ELECTRICAL LEGEND & NOTES

FORT WEAVER ROAD
ROUTE H-1 TO SOUTH OF
FARRINGTON HIGHWAY

CONTRACT CHANGE ORDER NO. 10
HIGHWAY LIGHTING REVISION

FAUSP NO. M-7600(1)

INTERSECTION NO. 4 SIGNAL PLAN 1"=20' NOTE: ALL FACILITIES ARE EXISTING, REPLACE SIGNALS AS INDICATED

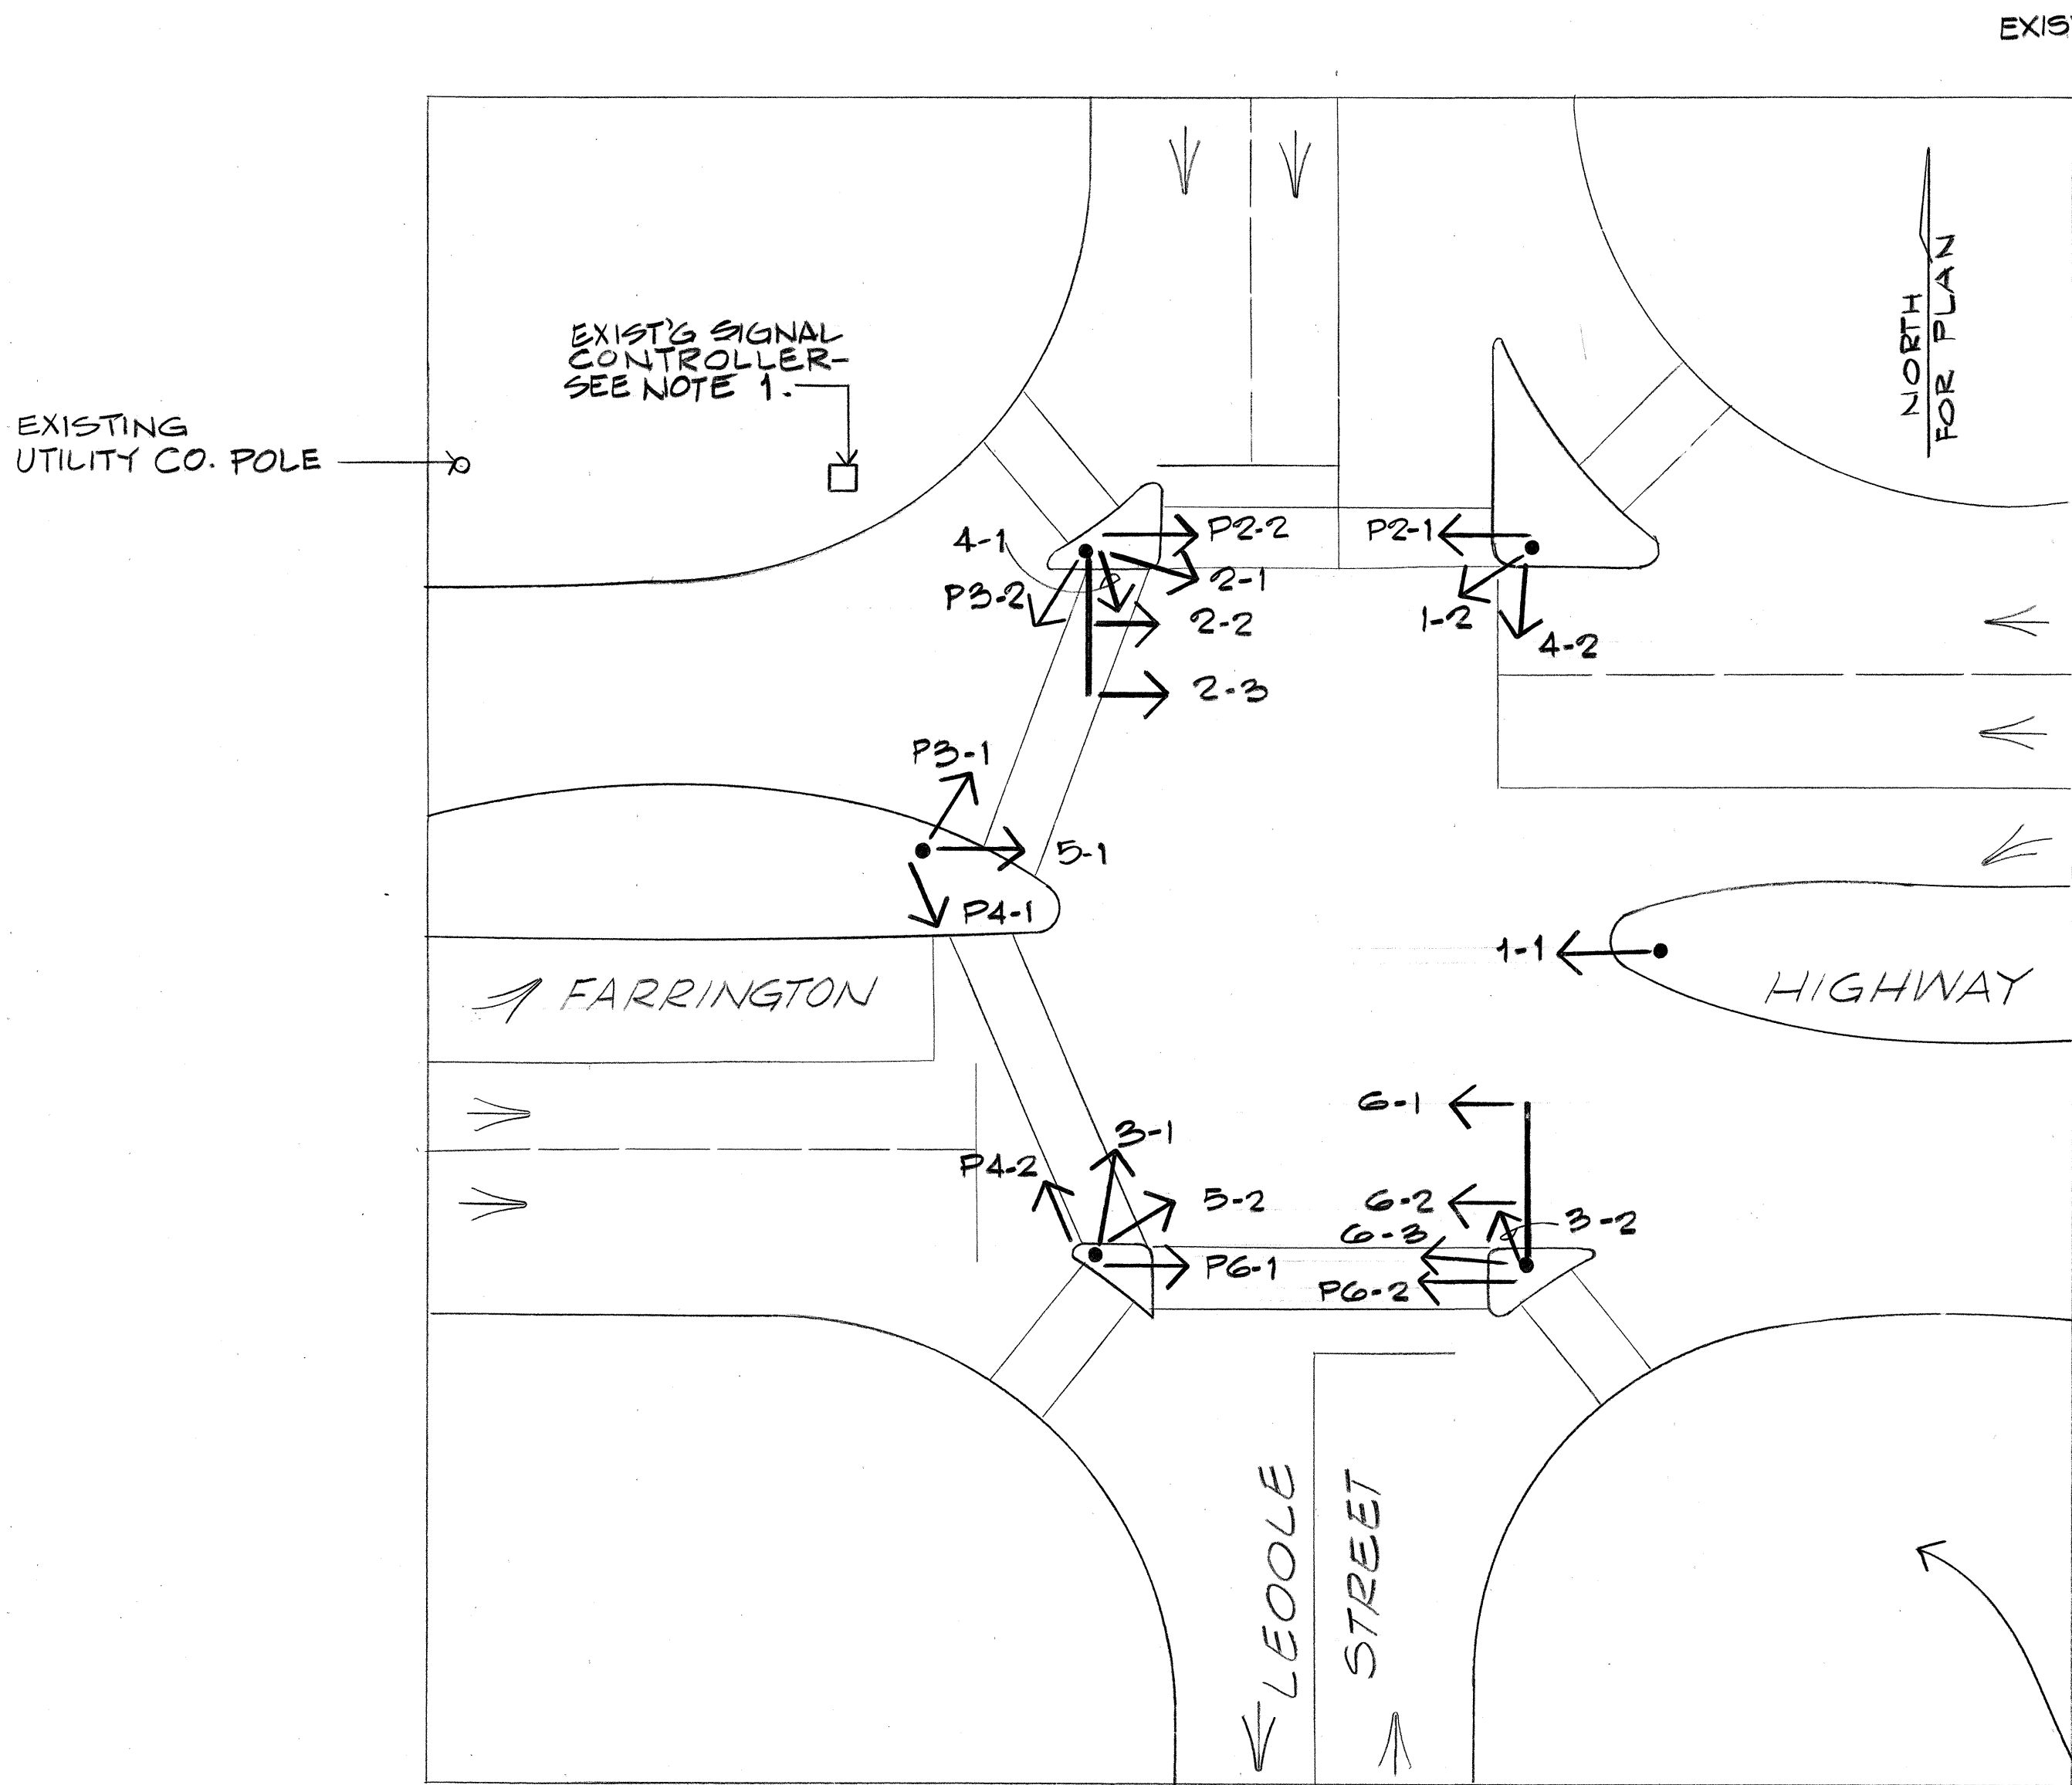
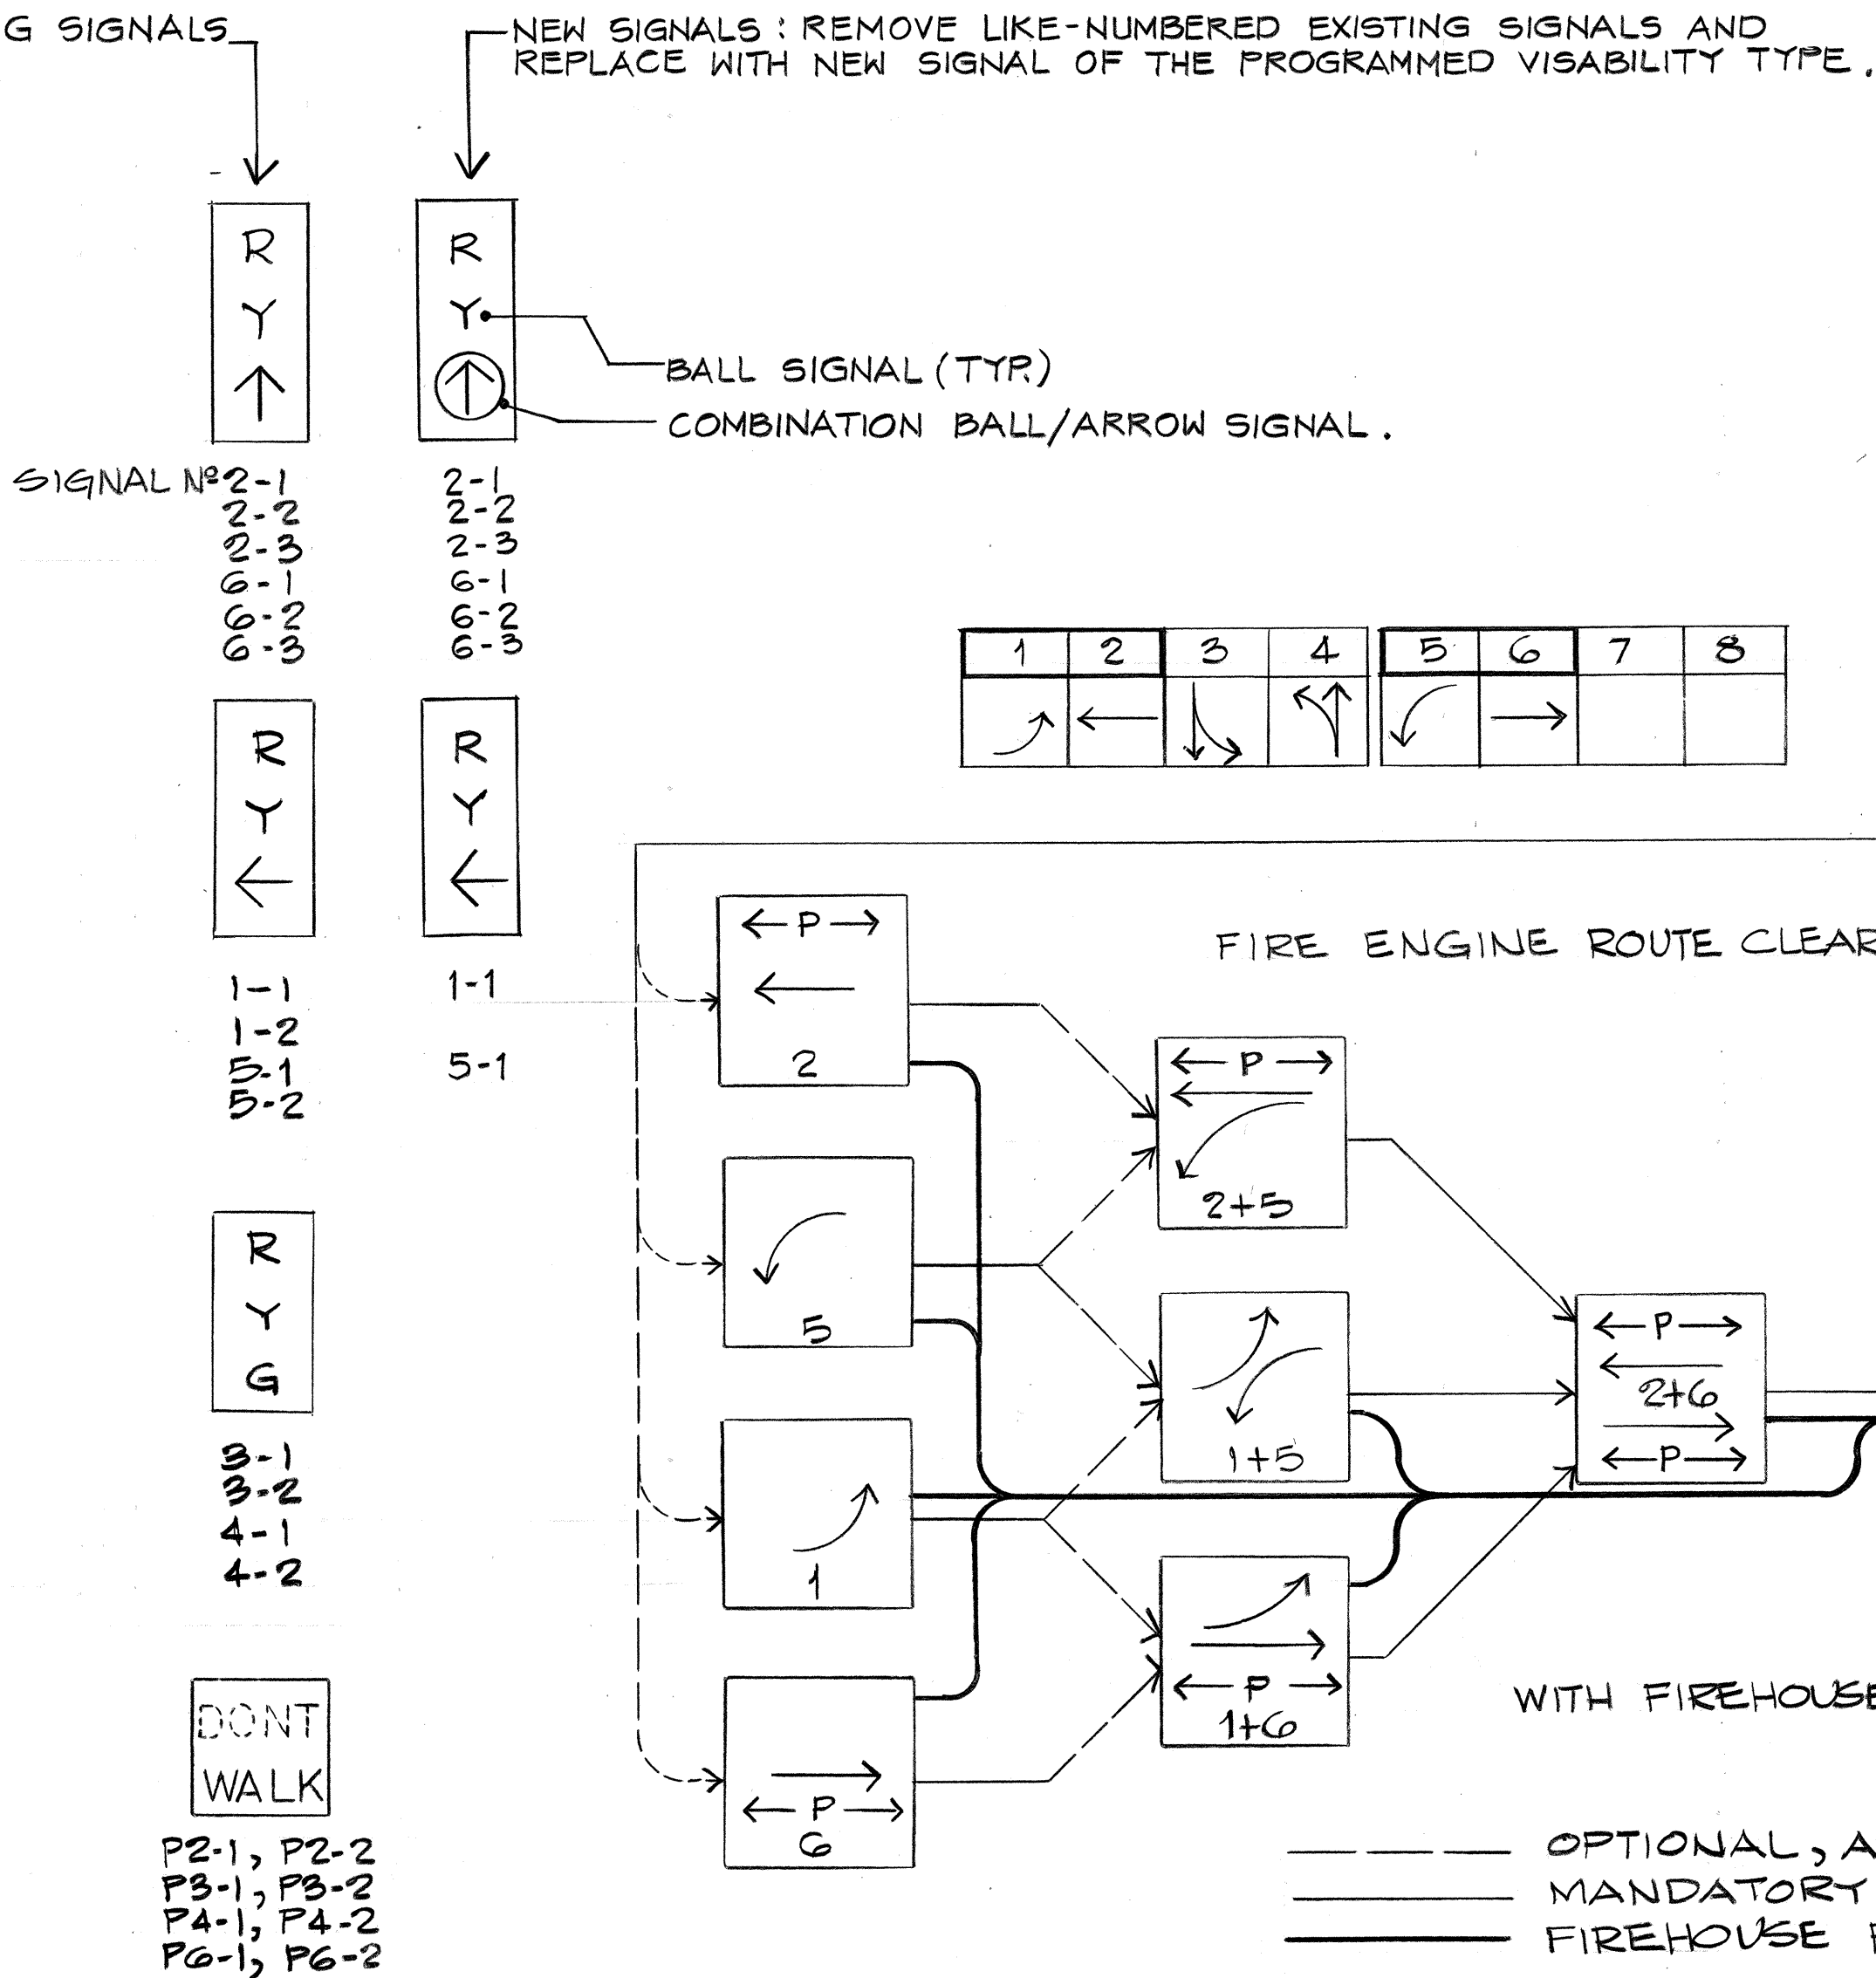
4-10-80	Revised Note 1. Added Notes 2 & 3.
DATE	REVISION

1. REMOVE AND DISPOSE OF EXISTING CONTROLLER AND CABINET. PROVIDE NEW CONTROLLER WITH PRE-EMPTOR IN NEW CONTROLLER CABINET.
2. REMOVE EXISTING 19c #14 LOOP CONTROL CABLE AND REPLACE WITH 26c #14 LOOP CONTROL CABLE.
3. COORDINATE ALL SIGNAL WORK WITH CITY & COUNTY OF HONOLULU, DEPARTMENT OF TRANSPORTATION SERVICES.
